Exception Request No.: 100
Town: Bethlehem
Highway: NH 18/116 (Tier 3)
Section: ROCK
Station: 151+00 to 156+50
Drawing No.: ROCK C119
Survey Report Reference No.: ROCK C118 to C119
Exception Type: Alignment in Pavement
Splice Enclosure in Pavement

EXCEPTION 101 - ALIGNMENT IN PAVEMENT & SPICE ENCLOSURE IN PAVEMENT
NPT ROCK-UNDERGROUND ALIGNMENT
ROCK SECTION- STA. 151+00 TO 156+50
SCALE: 1"=30'

TITLE:
EXCEPTION 100 - ALIGNMENT IN PAVEMENT
& SPLICE ENCLOSURE IN PAVEMENT
NPT-ROCK UNDERGROUND ALIGNMENT
ROCK SECTION-STA 156+50±
TOWN: BETHLEHEM

EXHIBIT A

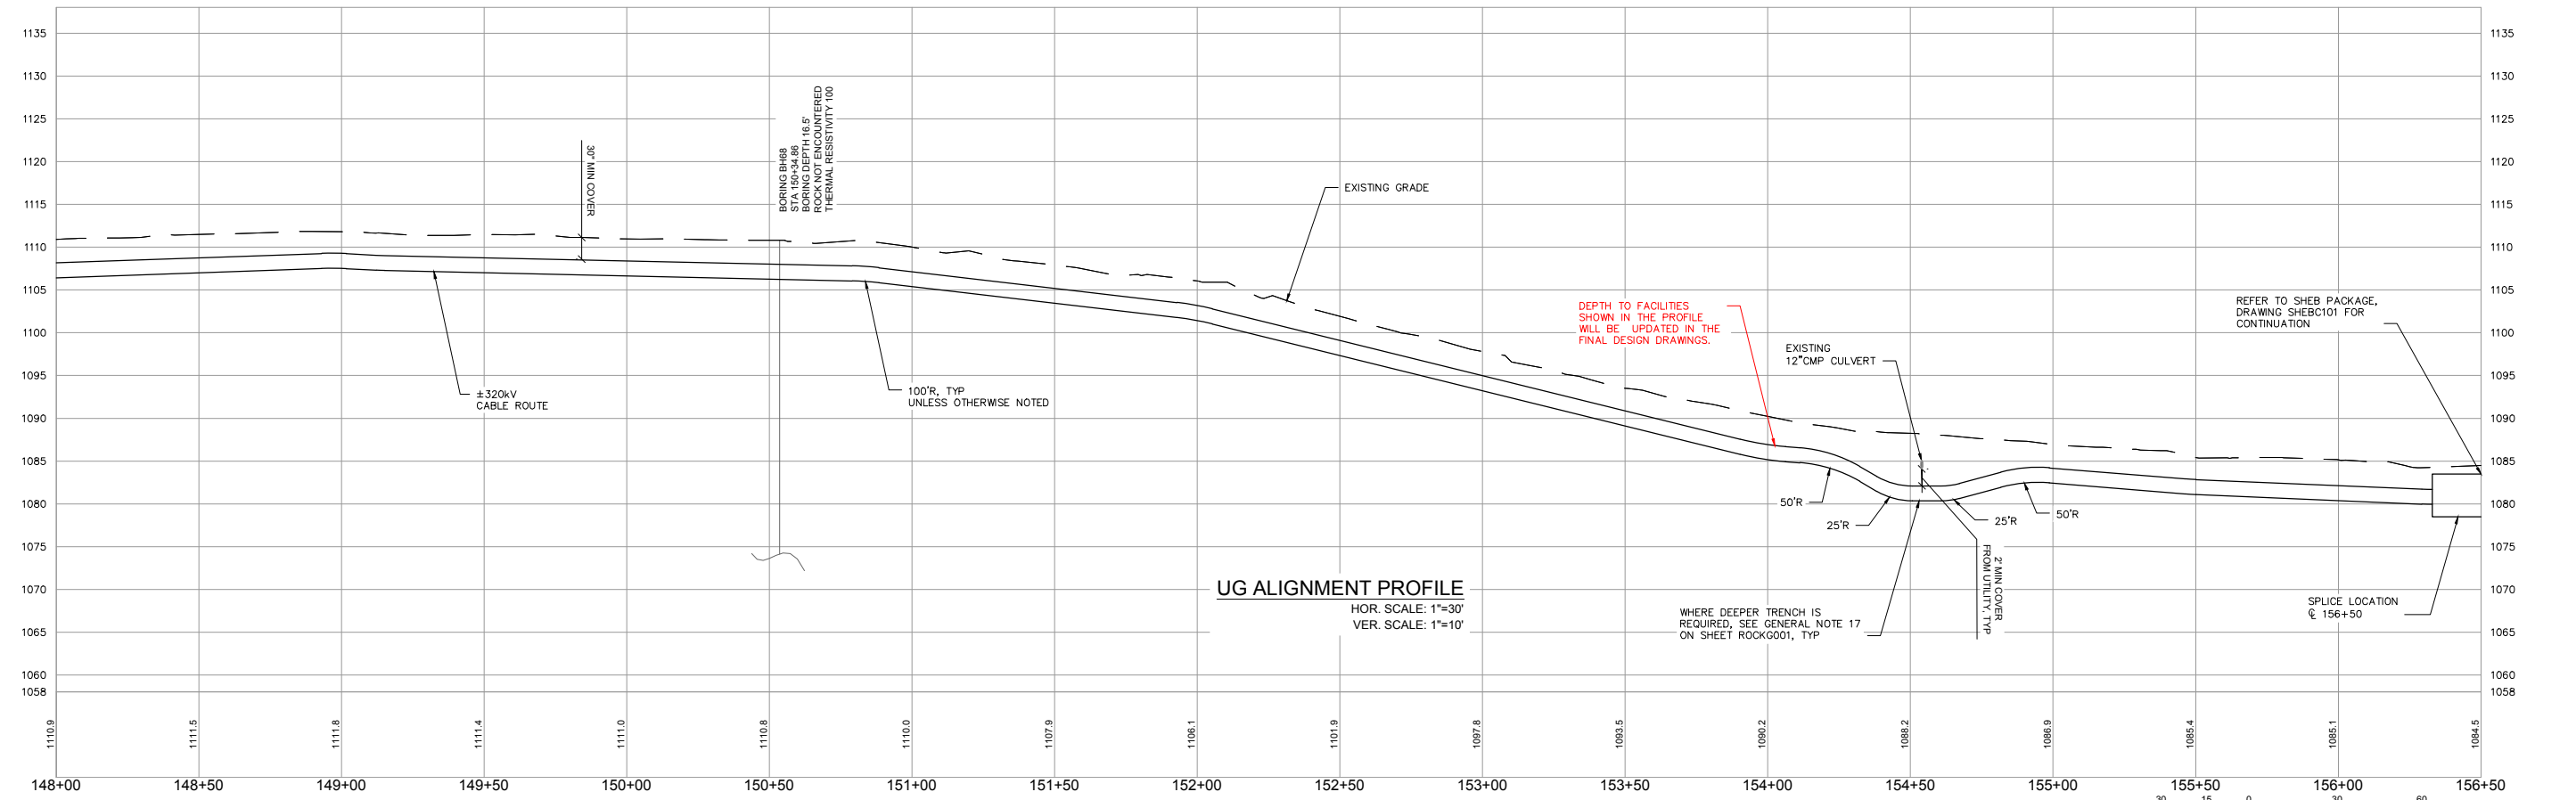
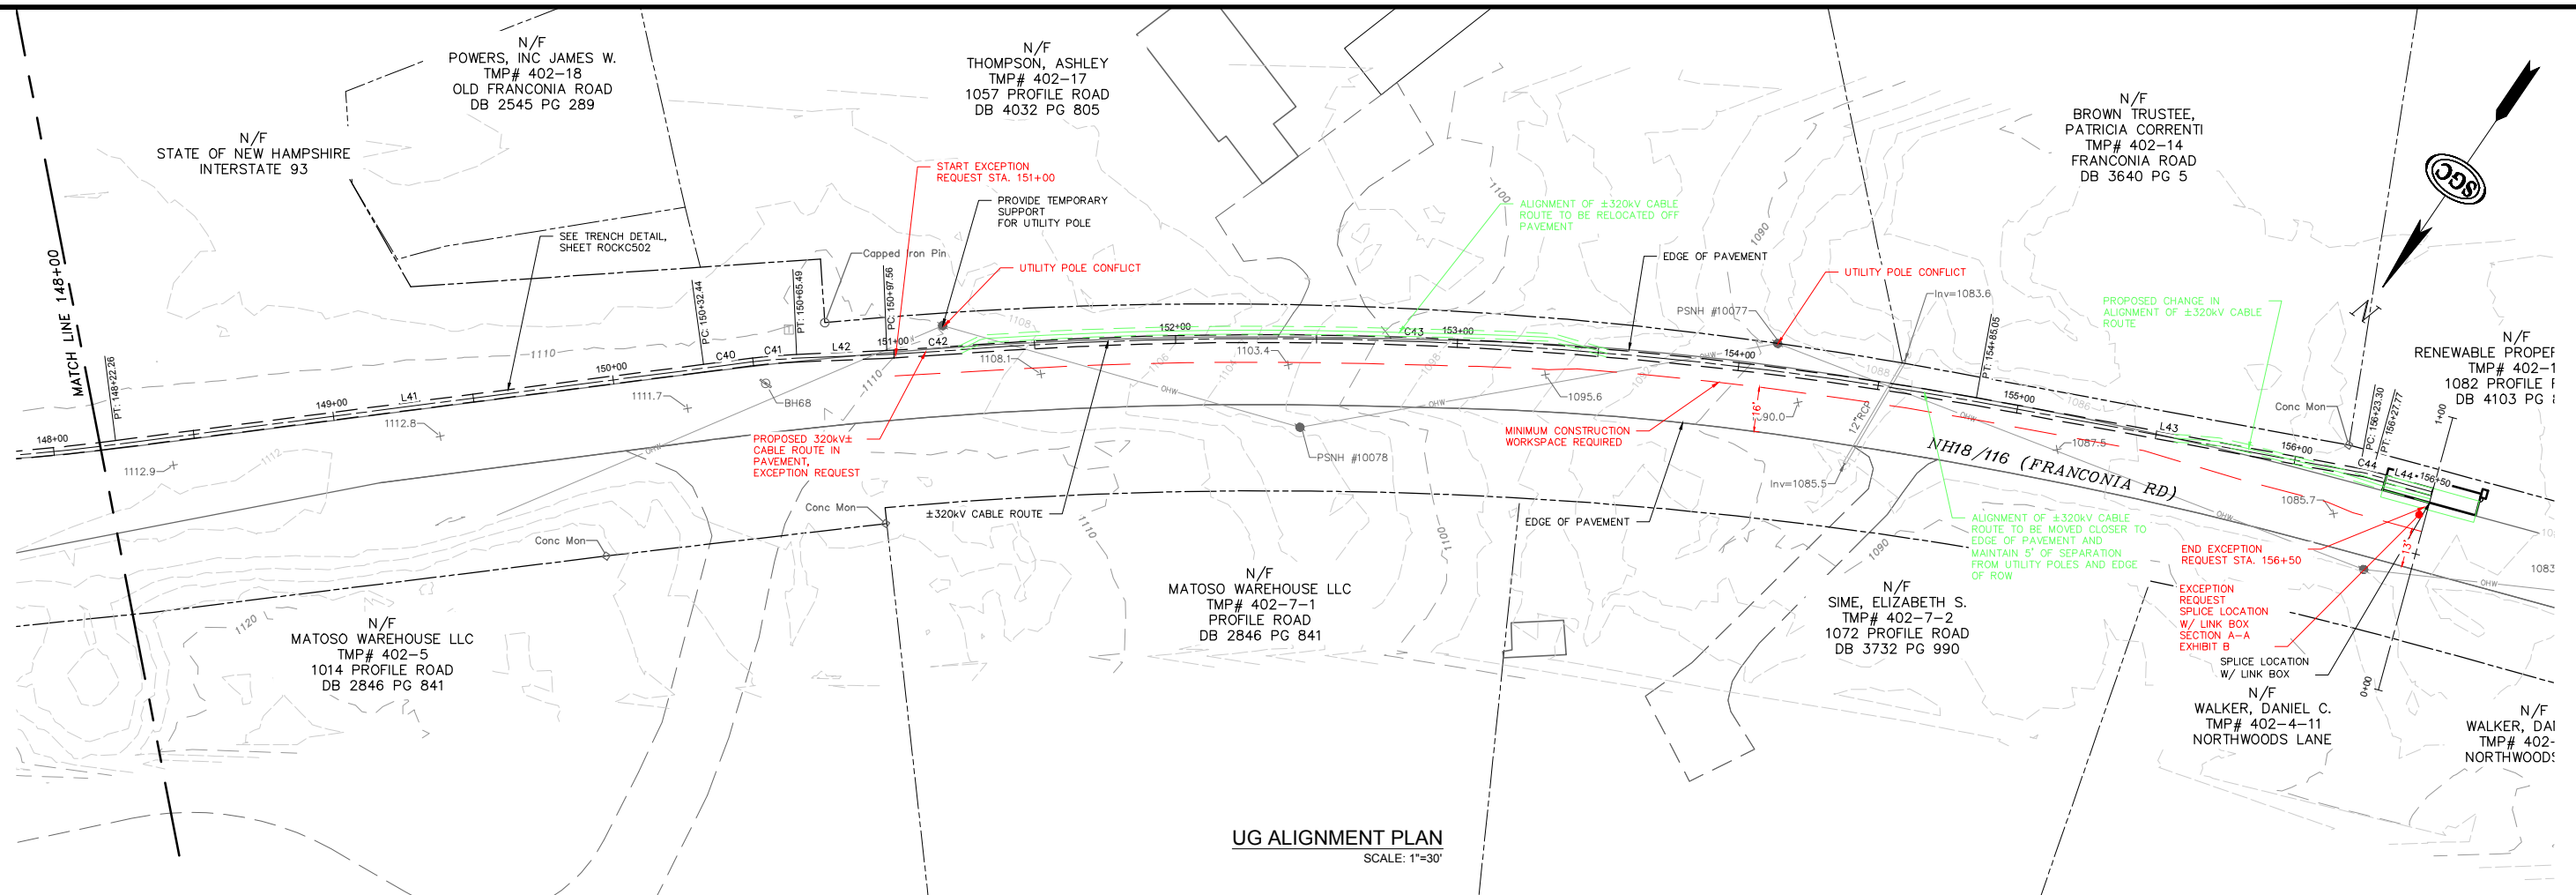
NPT is requesting an exception from the UAM guidelines for the location of the cable trench in the pavement on Highway 18/116, Franconia Road from station 151+00 to 151+25 and from station 153+25 to 156+50 of the NPT ROCK Underground Alignment. (See Exhibit A.) Due to limited ROW space outside the pavement and beyond the utility poles, construction outside the paved area is not practicable at this locations because NPT does not have the necessary property rights to construct outside the NHDOT ROW on private property.

It should be noted that we have moved the alignment out of the pavement between stations 151+25 to 153+25 (between the utility poles). In the original permit drawings, NPT proposed this entire alignment within the pavement. In response to NHDOT comments, NPT has reduced the overall length of the alignment within the paved area.

The proposed alignment is within the roadway because of constraints posed by a narrow ROW and utility poles on the south side of Franconia Road. The existing overhead distribution line runs along the south side of the ROW. At this location, the poles are currently located either close to or at the edge of the ROW. Relocating the utility poles at this location would require the acquisition of additional rights for the installation of poles, guys, and/or anchors on private property outside the NHDOT ROW, and is therefore not feasible.

NPT evaluated placing the cable trench alignment on the north side of the road in this area, however the alignment must stay on the south side of the road to the west of this location to match up with a

horizontal direction drill alignment. Similarly, the alignment would be preferred on the south side of the road to the east to avoid crossing the interstate 93 south bound ramps. Moving the alignment to the north side of the road would require construction of two additional highway crossings. NPT submits that any benefits of moving to the opposite side of the road are negated by the additional traffic impacts and additional delays associated with the construction of the road crossings.

The design, as proposed, will not adversely affect the design, construction, stability, traffic, safety, environmental commitments, maintenance, or operation of the highway. The alignment has been located 5-feet off the edge of utility poles to avoid future conflicts with pole repairs or replacement. The installation of the ductbank and pavement restoration will be designed and constructed in accordance with conditions outlined in the NHDOT's April 3, 2017 letter to the New Hampshire Site Evaluation Committee. The installation's proposed depth meets NHDOT's criteria relating to the structural box to minimize any potential conflicts with maintenance and future highway projects. A traffic control plan has been submitted to the NHDOT for this design and complies with the Manual on Uniform Traffic Control Devices.

EXHIBIT NO.: B

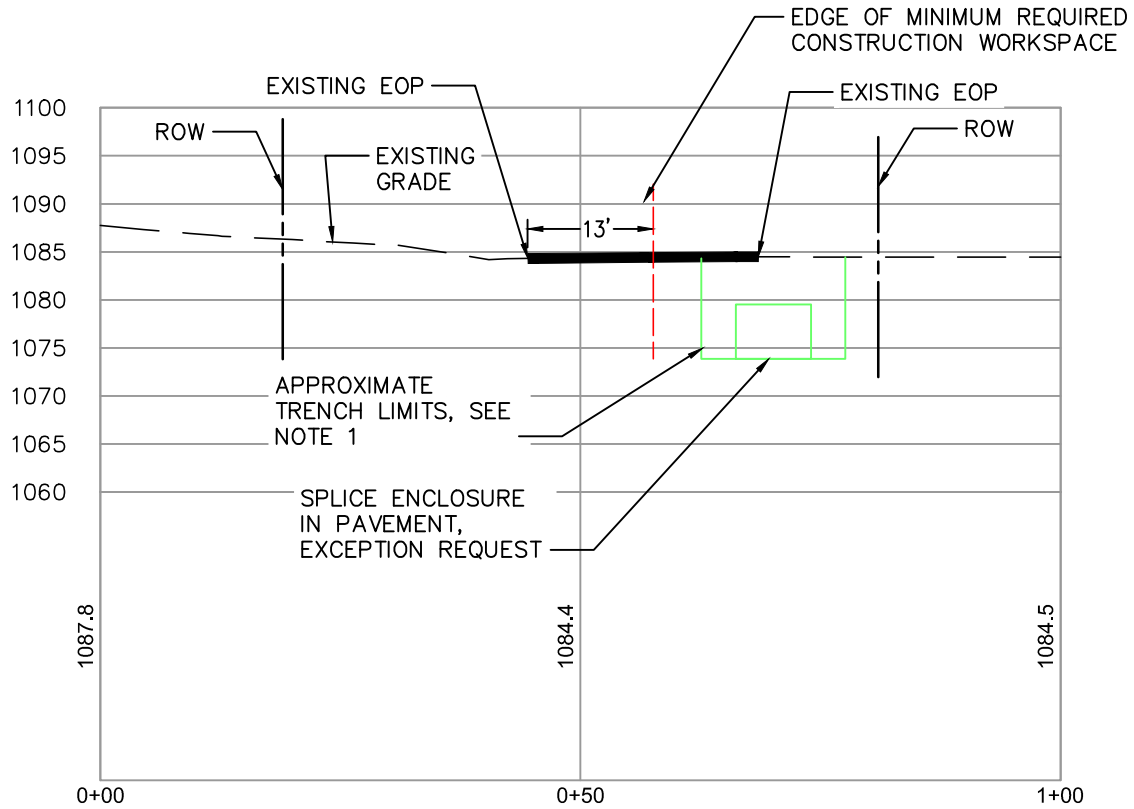
In addition, our exception request in this area includes a splice enclosure in the pavement at approximately station 156+50 of the NPT ROCK underground alignment section. The proposed location of the splice enclosure is set back 7' from the edge of ROW. The splice enclosure cannot be moved closer to the ROW limits because of the need for construction workspace.

As noted above the alignment on the south side of the road at the splice enclosure location, (Station 156+50) is tied to the horizontal direction drill alignment to the west, included in the SHEB section (drawing SHEB C101). The proposed location of the splice enclosure is set back 7-feet from the ROW limit to allow for adequate construction work space and additional space for the installation of erosion controls at the ROW line. As a result, the proposed location of the splice location is partially within the pavement. See Exhibit B.

The design, as proposed, will not adversely affect the design, construction, stability, traffic, safety, environmental commitments, maintenance, or operation of the highway. The proposed splice enclosure and ancillary enclosures will be of a minimum rating of HS-20, in accordance with NHDOT requirements. The installation of the enclosure and pavement restoration will be designed and constructed in accordance with conditions outlined in the NHDOT's April 3, 2017 letter to the New Hampshire Site Evaluation Committee. The installation's proposed depth meets NHDOT's criteria relating to the structural box to minimize any potential conflicts with maintenance and future highway projects.
